STAFF REPORT FEBRUARY 12, 2025, REGULAR MEETING

APPLICATION NUMBER: HDC2025-00028

ADDRESS: 3020 IROQUOIS

SCOPE: ERECT DWELLING

Rendering of proposed building, from application materials.

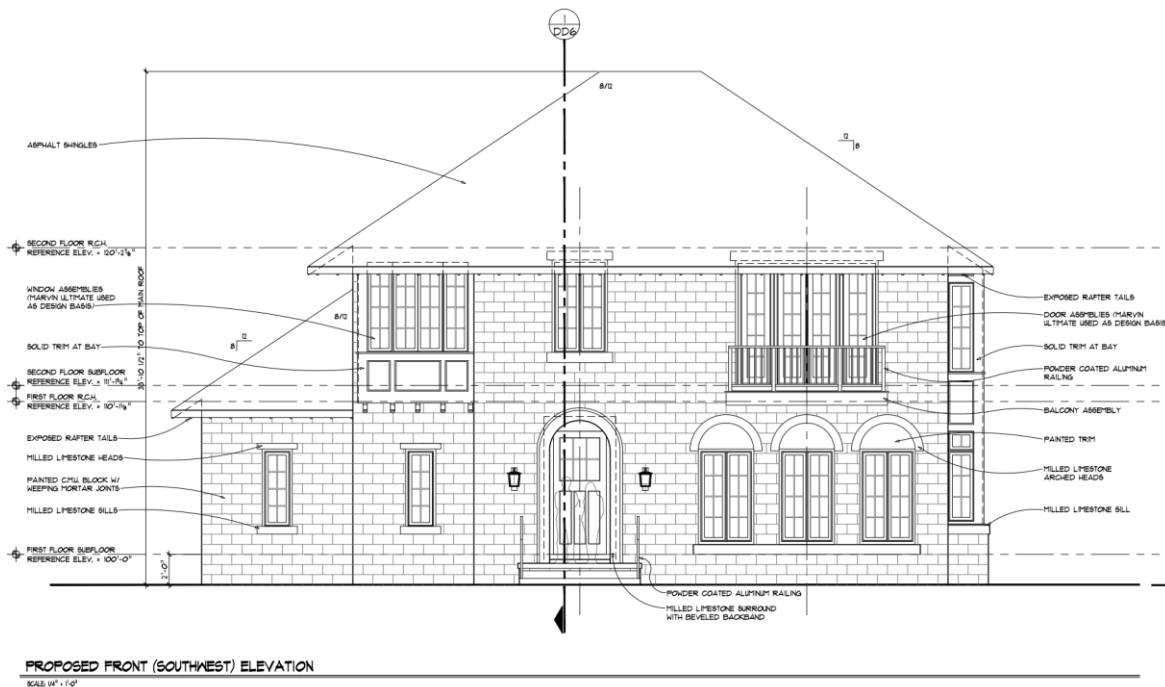
Staff assessment: The proposal features a two-car, attached garage that is inconsistent with this element as it is not “at the rear” with doors “generally not visible to the street.” Staff assesses that while an attached garage is reasonably appropriate for a new construction house, its visibility should be limited. The landscape plan shows that this is partly accomplished with landscaping, particularly a proposed magnolia that is expected to reach 8 feet in height at maturity. Visibility is also partly blocked by the placement of the non-historic house to the north, which is placed closer to the street than the historic houses on the block. However, staff notes that the garage door is not specified (see “Issues,” below). Although the garage appears to be appropriate in elevation, the choice of the door will affect how clearly it will be noticed from the street. A darker color will help it recess and be less conspicuous, as will division of the panels into smaller units to reduce its apparent horizontal emphasis and flatness. A choice of textures or designs expressing depth or shadow lines will help it appear less flat, especially in the division of the proposed windows. Additionally, the garage opening itself could be divided into two single bay doors, divided by a pier, similar to many historic prototypes in the district. In conclusion, this element is not fully satisfied, but can be mitigated.

- The proposed alternative painted brick depicted on page 13 of the submitted drawings shall be used; painted CMU shall not be used.
- The elm tree shall be retained (the mulberry may be removed).
- The final selection of garage door shall prioritize an inconspicuous design, subject to review by staff.

Proposed painted CMU (left) and alternate painted brick (right). Images from application materials.

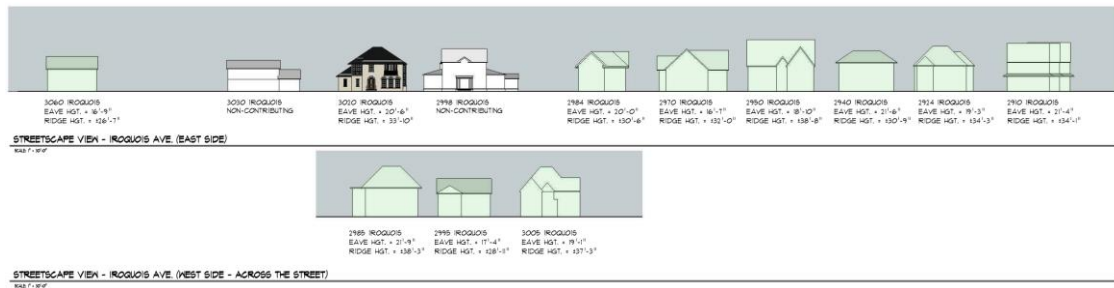
Staff assessment: Of all the elements, this is one of two that are clearly not satisfied. The proposed CMU material is not found in Indian Village; its appropriateness as a non-historic material is discussed separately below. The optional proposed alternative, painted brick, would meet this element (though it would fail the subsequent element; its appropriateness is also discussed separately below). The other proposed materials of wood, stone, and asphalt shingles would meet the elements of design.

Staff assessment: This is the other of the two elements that is not satisfied. The proposed CMU material would introduce a novel texture to the district. The painted brick alternative would provide the prescribed “low-relief pattern of mortar joints in brick,” but then diminish the visibility of this texture by painting it a monochrome color. (Additional analysis is provided separately below.)

- Although not specifically stated in the narrative, it seems that the proposed painted CMU may be intended as a reference to the general visual qualities of true stucco. Indeed, that would be the strongest argument for its compatibility, in the opinion of staff. However, staff opinion is that the unitized (by definition) nature of CMU is fundamentally at odds with the seamless finish of trowel-applied stucco.

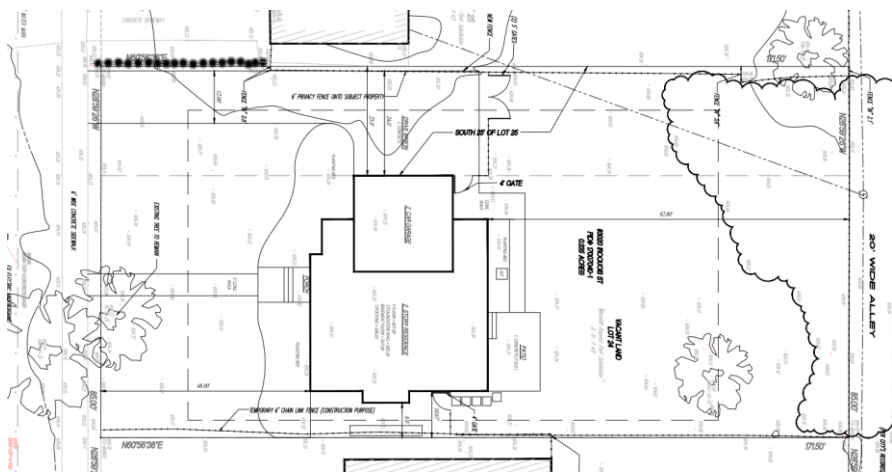
Staff assessment: The proposed hip roof is consistent the Elements of Design; many side-hip roofs are found within the district, both with and without dormers (see example photos on page 7; note also that the dormers at 2168 Burns do not appear to be original). This element appears to be satisfied.
